# ACCELERATED DISTRIBUTION DEMONSTRATION SYSTEM

SUBJECT: Forwards Rev 26 to "Turkey Point Radiological Emergency Plan" & Rev 26 to EPIPs 20101, 20111, 20126, 20129, 20130 & 20133.

Re: Turkey Point Units 3 and 4  
Docket Nos. 50-250 and 50-251  
Emergency Plan Implementing Procedures and  
Radiological Emergency Plan - Revision 26

SUMMARY OF REVISION 26 CHANGES  
TO THE TURKEY POINT NUCLEAR PLANT RADIOLOGICAL EMERGENCY PLAN

**FIGURE 1-2**  
**INITIAL NOTIFICATION**

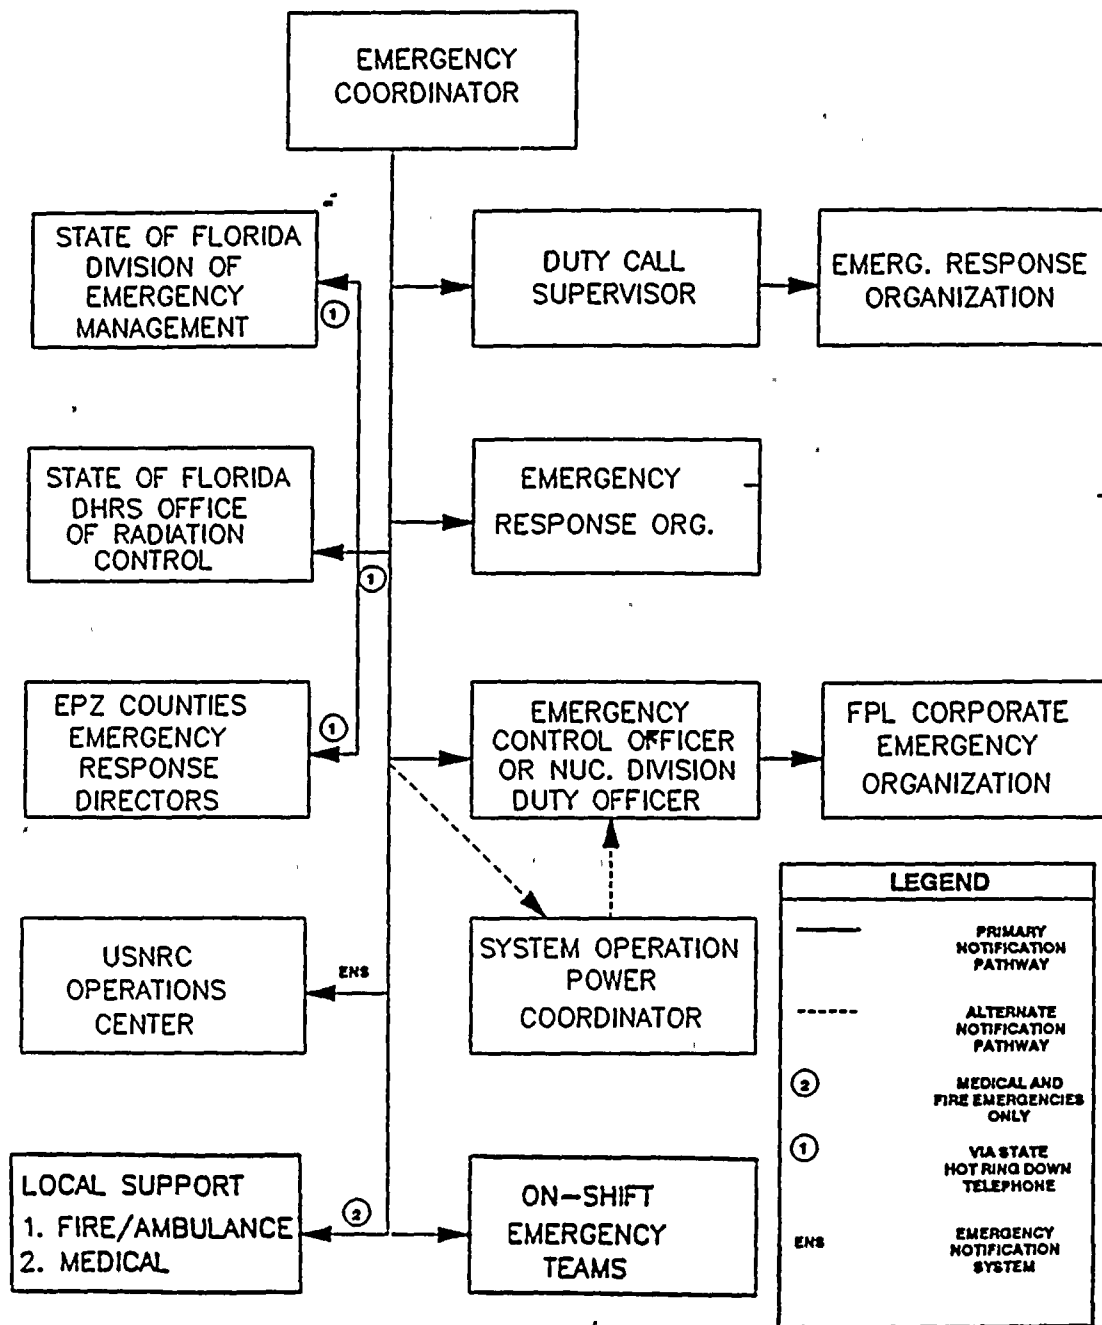
<u>Page</u>	<u>Section</u>	<u>Description of Change</u>
1-12	Figure 1-2	<u>Initial Notification</u> - changed ECO notification to reflect alternate methodology "...via the DCS or NDDO..." as previously described.
2-4	2.1.2	<u>Division of Florida Highway Patrol, Department of Highway Safety, and Motor Vehicles</u> - changed Appendix A to Annex B to reflect current revision of the State plan.
2-4	2.1.2	<u>State of Florida Response Organization - Other State Agencies</u> - Deleted reference to specific agencies, and added "The DEM can request support, as necessary, from other State agencies as defined in Annex B of the State Plan." This change will prevent discrepancies between the State plan and Turkey Point's plan, and will not reduce the available resources provided by the State.
2-4	2.1.3	<u>County Response Organization</u> - Third paragraph, changed Section XII to Annex K to reflect change in State plan.

FIGURE 2-3

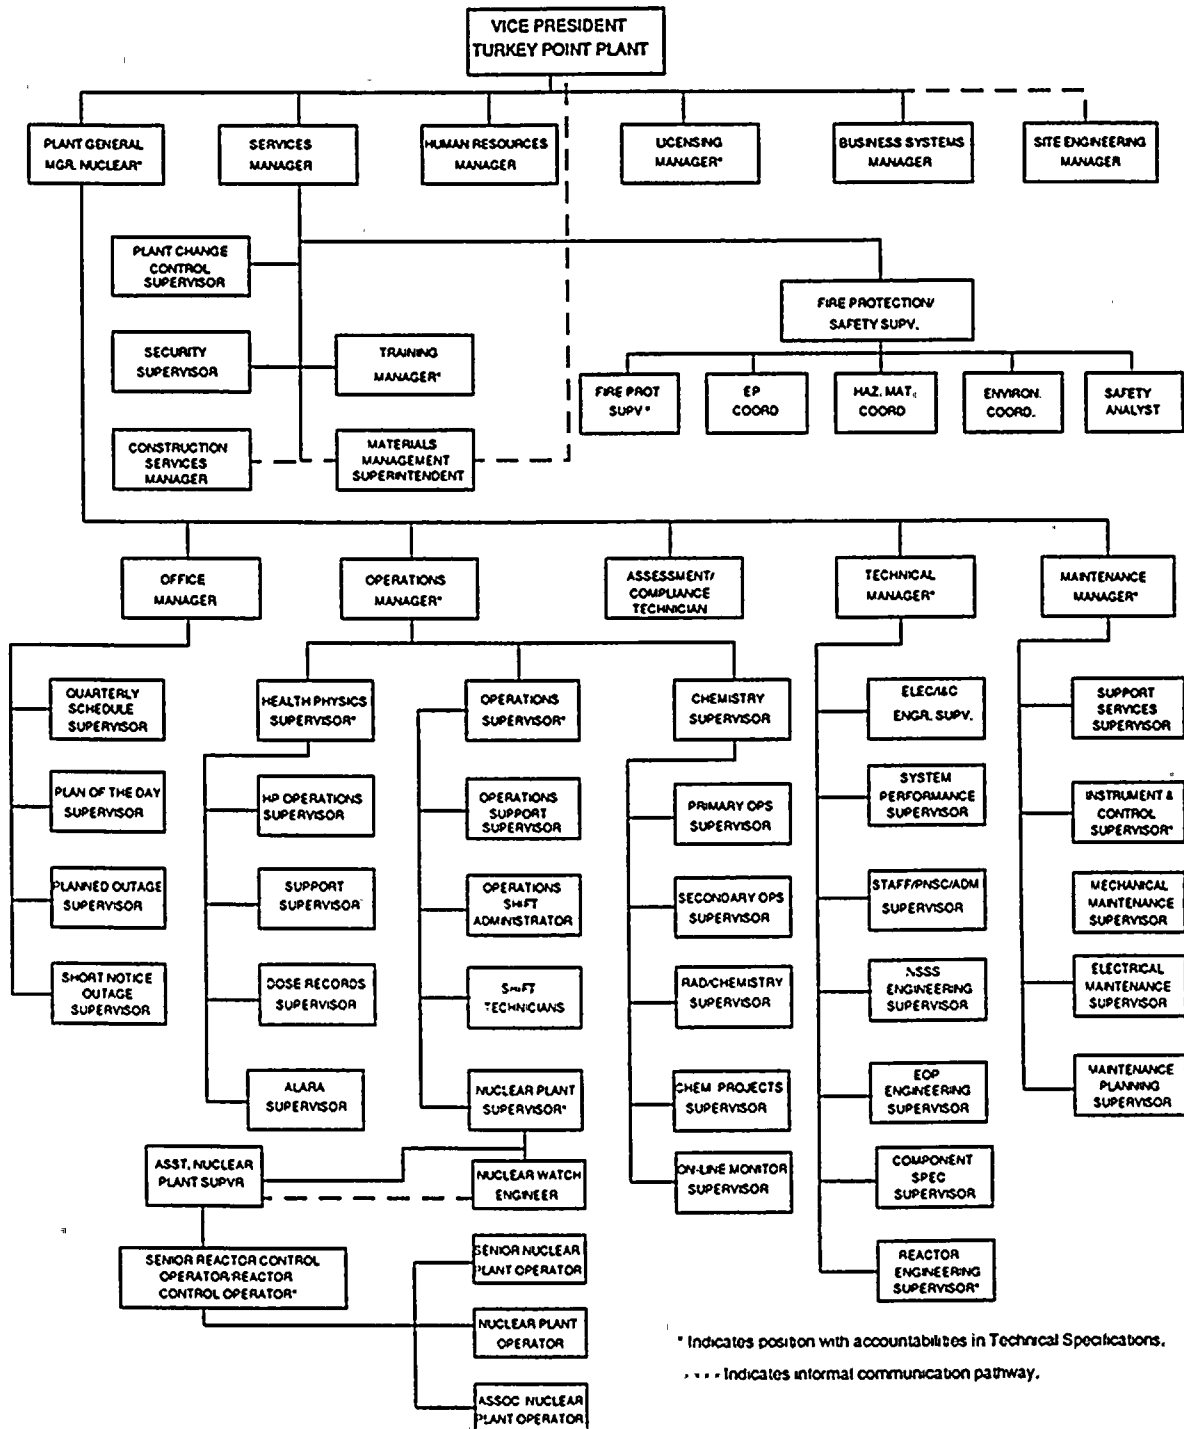
2-7	2.1.3	<u>County Response Organizations</u> - Changed "Director, Division of Public Safety, Planning and Assistance" to "Director, Division of Emergency Management" to reflect current State titles.
2-11	Figure 2-3	Turkey Point Plant Normal Operating Organization - updated to reflect organizational changes.
2-13	2.2.1	<u>Normal Operating Organization</u> - Technical Department Manager - (Pg 2-15) deleted reference to Document Control Section, which now reports to the Services Manager.
2-17	Figure 2-4	Modified organization to reflect hierarchy of positions.
2-20/21	Table 2-2a	Deleted a note which no longer applies and corrected a typographical error.
3-1,2,3	3.1,2,3,4	Added clarification words to action steps regarding periodic plant status updates. The same action is applicable under all emergency classifications, and reads: "Provide periodic plant status updates in accordance with plant procedures, typically every sixty minutes, upon significant change in plant conditions, or as agreed to with State County, and Federal Agencies."

**FIGURE 4-1**  
**INITIAL NOTIFICATION**

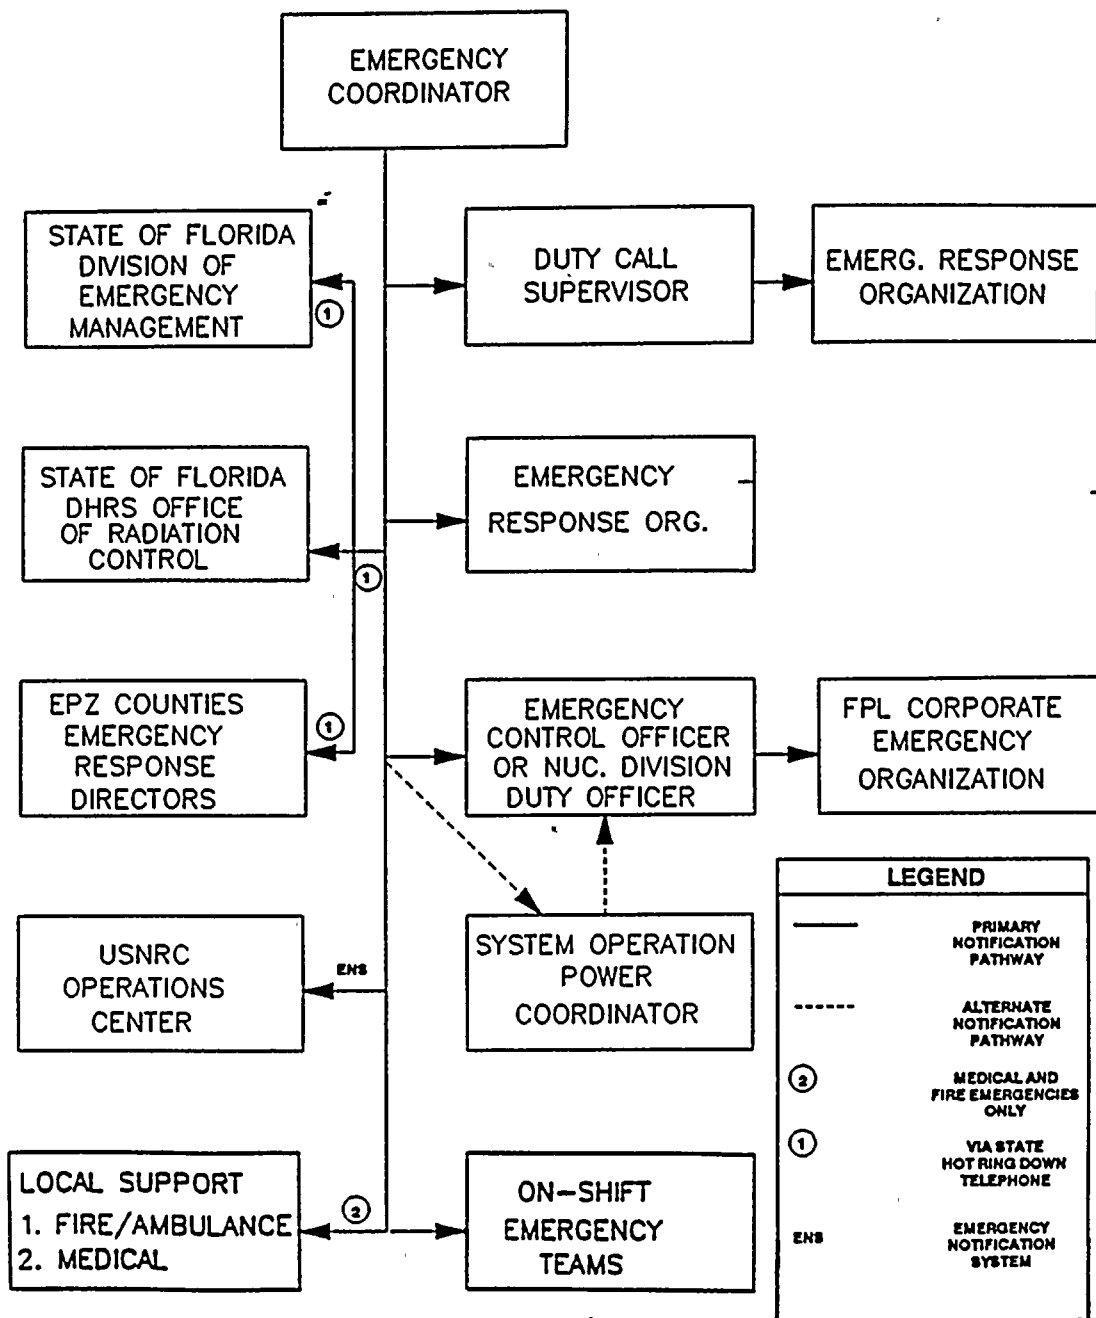
4-1	4.0	Changed reference to Initial Notification Flowpath from Figure 4-1 to Figure 1-2. Therefore, Figure 4-1 is deleted because it is identical to Figure 1-2.
4-2	4.1.1	Added Duty Call Supervisor to ECO notification methodology consistent with earlier changes.
4-3	Figure 4-1	Deleted; identical to Figure 1-2.
4-4	Table 4-1	Added specific names for onsite and corporate emergency response facilities. Clarified wording and punctuation in State and County facility titles.
4-7	4.3	Added Monroe County Sheriff's Office to county locations manned on 24 hour basis for notification via the State Hot Ring Down System.
4-8	4.4.1	<u>US Nuclear Regulatory Commission - Communications</u> - changed "activated" to "operational" to clearly establish when communications will be transferred to a facility (TSC or EOF).
4-10	4.6	<u>Communications Equipment</u> - revised description of the Company Radio System being less specific about actual radio bands (UHF/VHF), and adding reference to mobile radios in vehicles. This change will allow greater flexibility to enhance radio communications without needlessly changing the E-Plan.
